RE: **Lot 1 Block 7 Unit 18 SAD 228**
6532 Pato Rd. NW
Grading and Drainage Plan
Engineers Stamp Date 11/3/2025 (D10D003L1, HYDR-2025-00395)

Based upon the information provided in your submittal received 11/13/2025, this plan is approved for Grading Permit.

ENGINEER'S SEAL	LOT 1, BLK 7 U 18 VC 6532 PATO ROAD GRADING AND DRAINAGE PLAN	DRAWN BY DEM
		DATE 11-1-25
11/3/25		SHEET # C1
DAVID SOULE P.E. #14522		JOB #

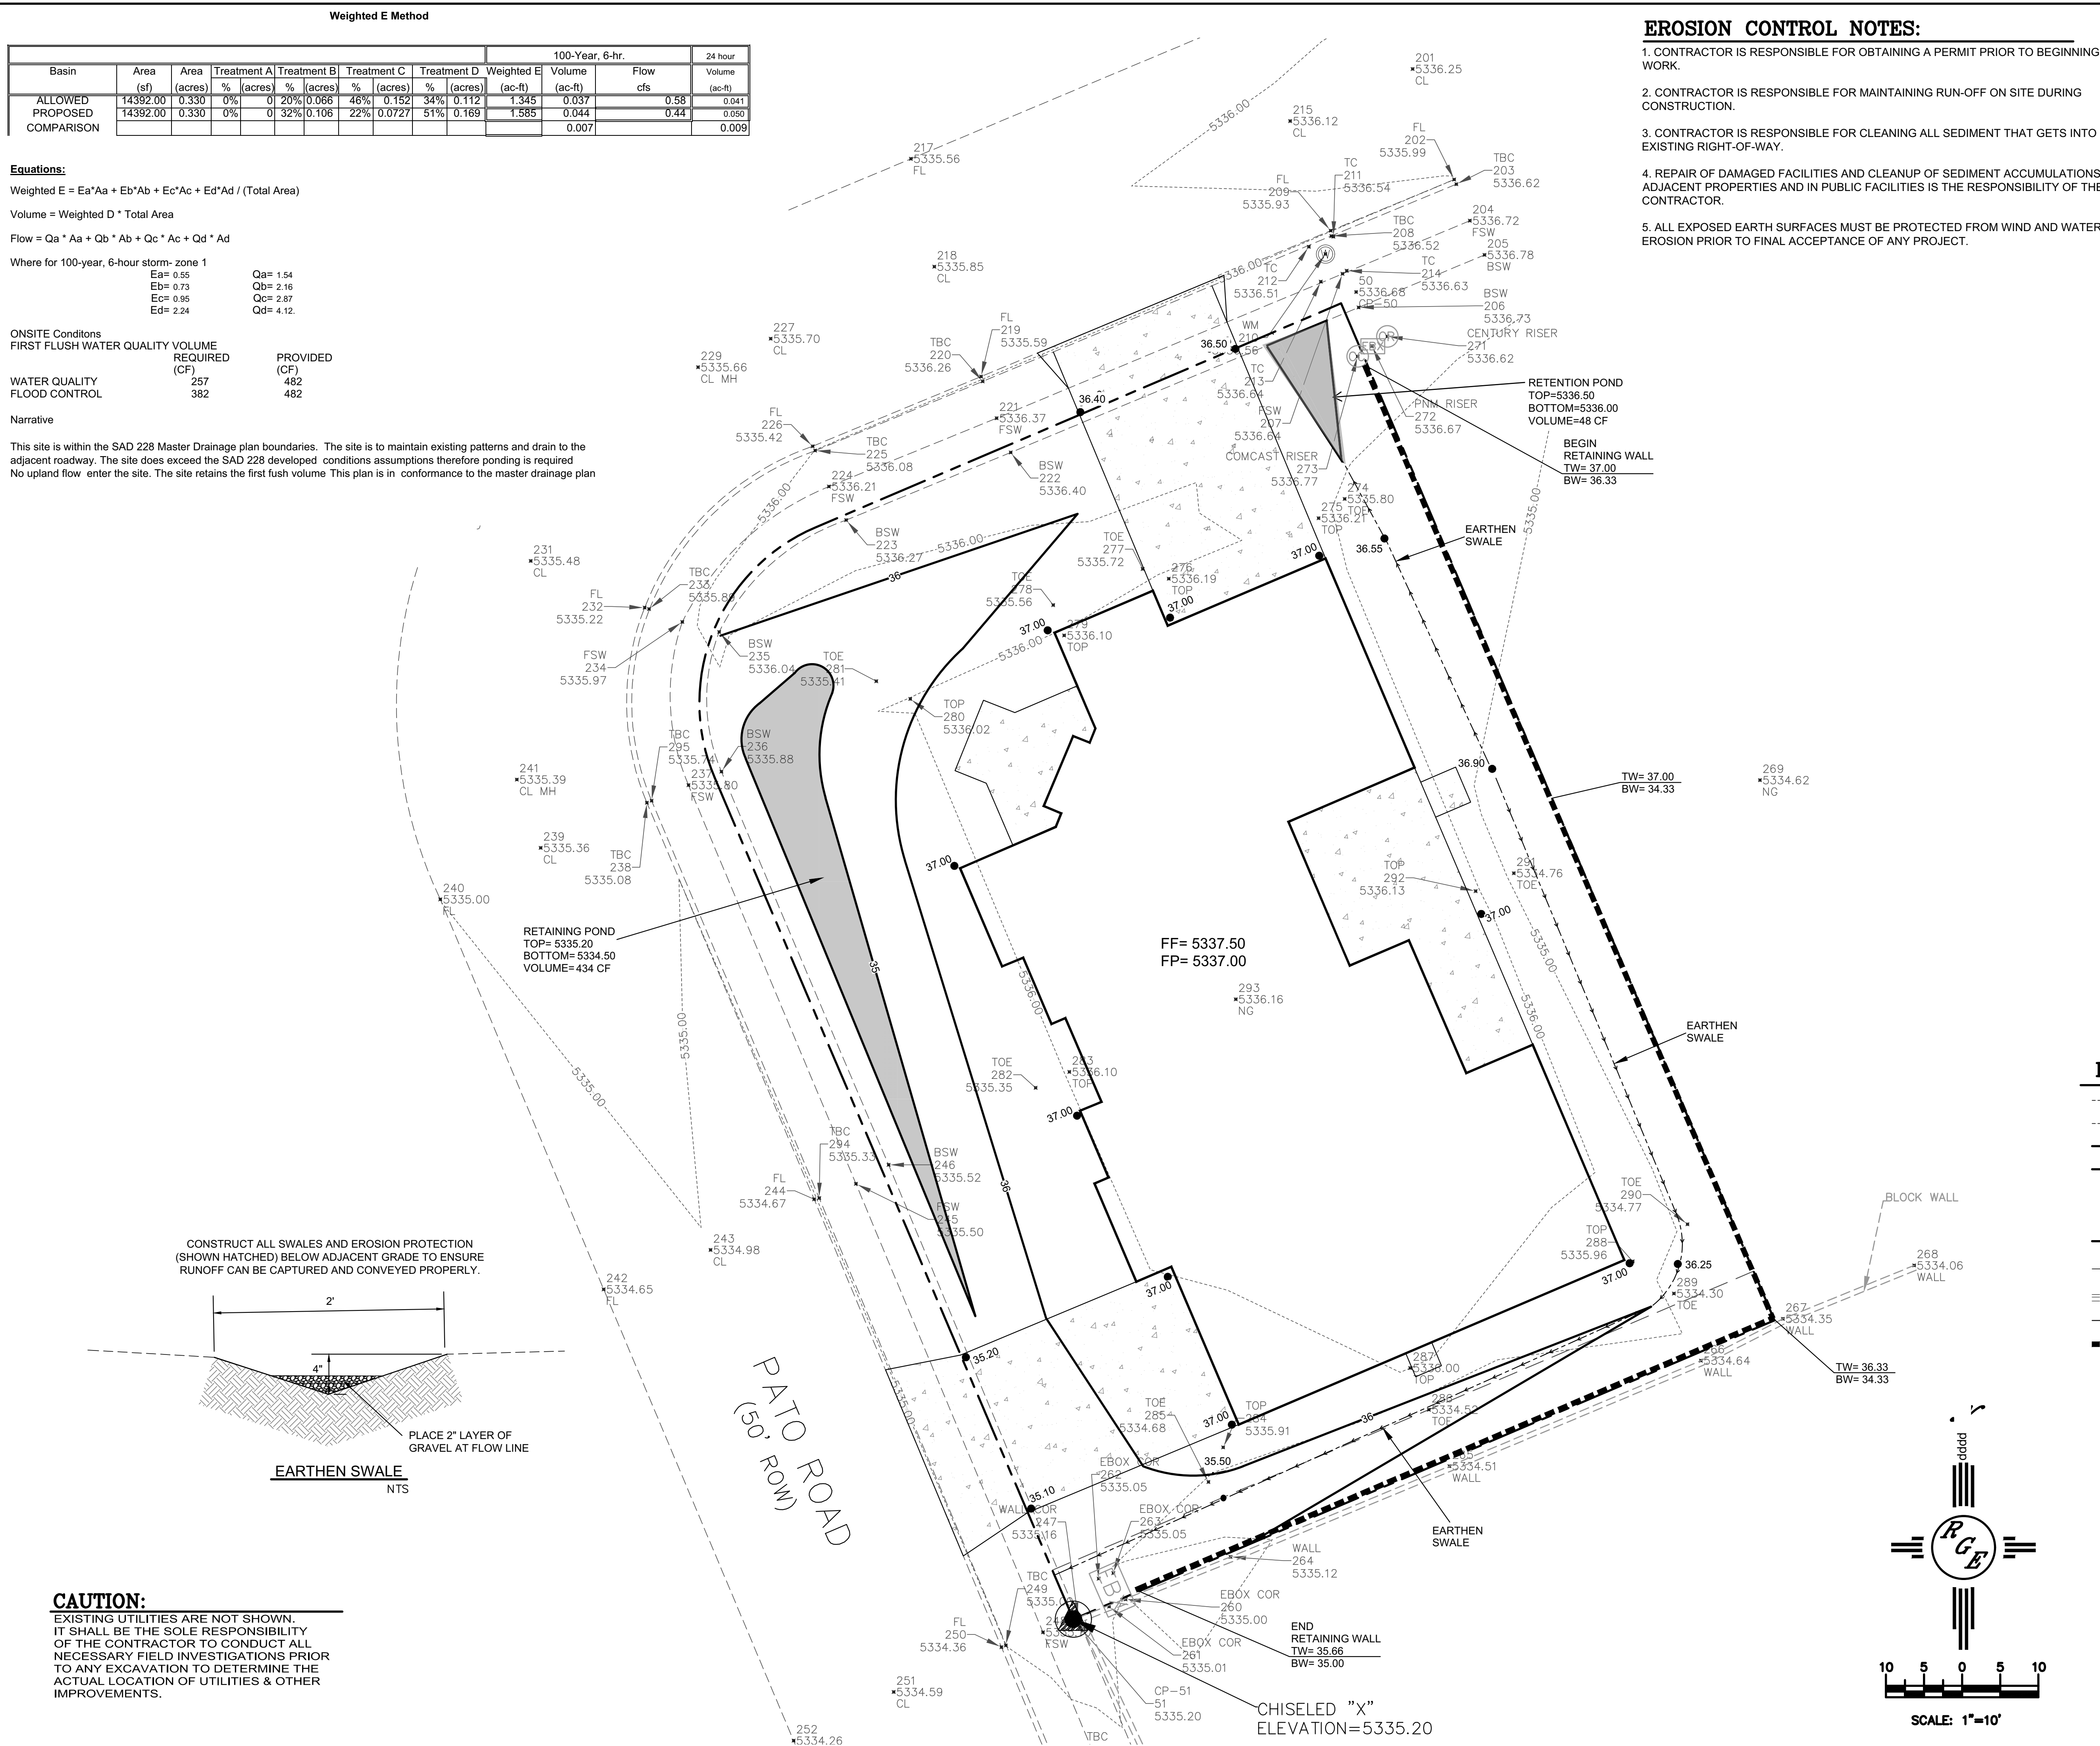
Prior to Building permit approval, a Pad Certification will be required, provided by the Engineer or a registered Land Surveyor.

Advise the owner contractor not to use dirt as a ramp to climb the curb, use lumber or crusher fines for this purpose.

Reiterate to the Owner/Contractor that a separate permit for a garden/retaining wall must be obtained with the approved G&D plan and Pad Certification. Also, if a swimming pool is to be placed the grading and drainage plan will change and will need to be resubmitted.

Prior to Certificate of Occupancy release, Engineer Certification per the DPM checklist is required.
